APPLICATION NO.	FILING DATE	FIRST NAMED INVENTOR	ATTORNEY DOCKET NO.	CONFIRMATION NO.
10/524,591	02/15/2005	Stephane Desrues	Q86236	6559
23373 7590 12/21/2006 SUGHRUE MION, PLLC 2100 PENNSYLVANIA AVENUE, N.W. SUITE 800 WASHINGTON, DC 20037			EXAMINER WUJCIAK, ALFRED J	
			ART UNIT	PAPER NUMBER
			3632	
SHORTENED STATUTORY PERIOD OF RESPONSE		MAIL DATE	DELIVERY MODE	
3 MONTHS		12/21/2006	PAPER

Office Action Summary

This is the first Office Action for the serial number 10/524,591 ASSEMBLY DEVICE FOR MOUNTING A DISPENSING ELEMENT TO THE NECK OF A CONTAINER, filed on 2/15/05.

Fig.3

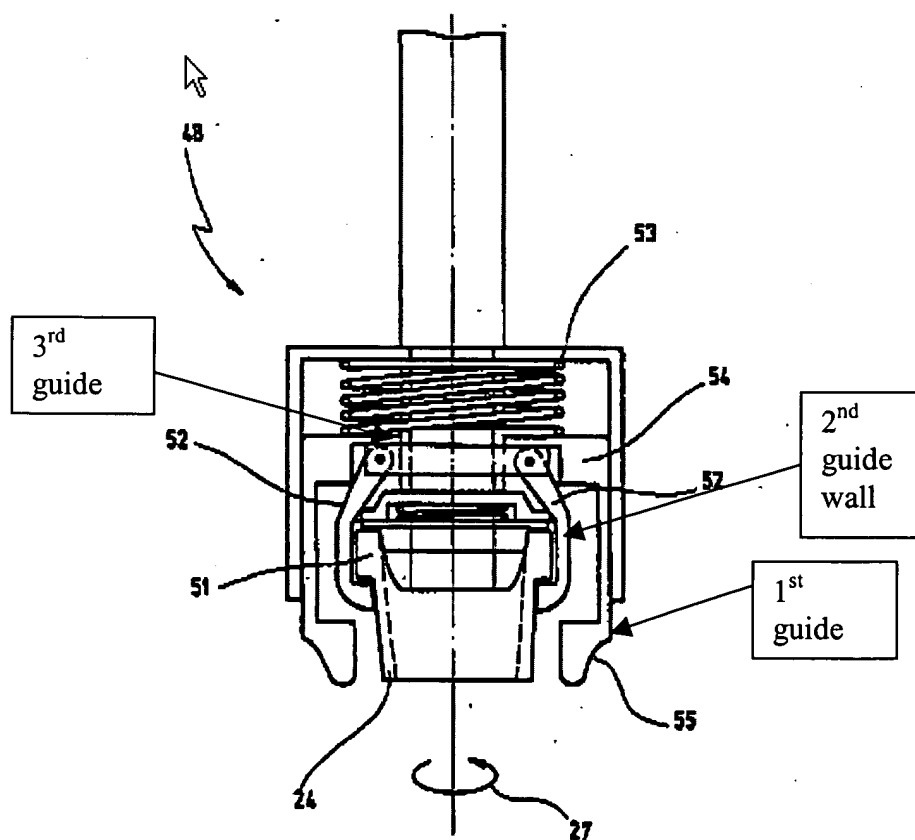
Jahn et al. teaches a mounting equipment (figure 3) comprises a first guide wall (55), a second guide wall (52) and a thrust member (53). The second guide wall is formed by a thrust member (53). The second guide wall is displaceable relative to the first guide wall between a rest position and a thrust position. The first guide wall is frustoconical, at least in part, and

converges to toward to the second guide wall. The equipment includes a third guide wall (cylindrical object inside of U-shape element that is in contact with element 55 and adjacent to element 53). The second guide wall is displaceable relative to the third guide wall between a rest position and a thrust position. The third guide wall is being masked in the rest position and unmasked in the thrust position. The first guide wall and the third guide wall are secured to each other and static relative to each other. The first guide wall is frustoconical, at least in part, and is extended by a substantially cylindrical portion forming the third guide wall. The thrust member is urged towards its rest position by resilient return means (spring).
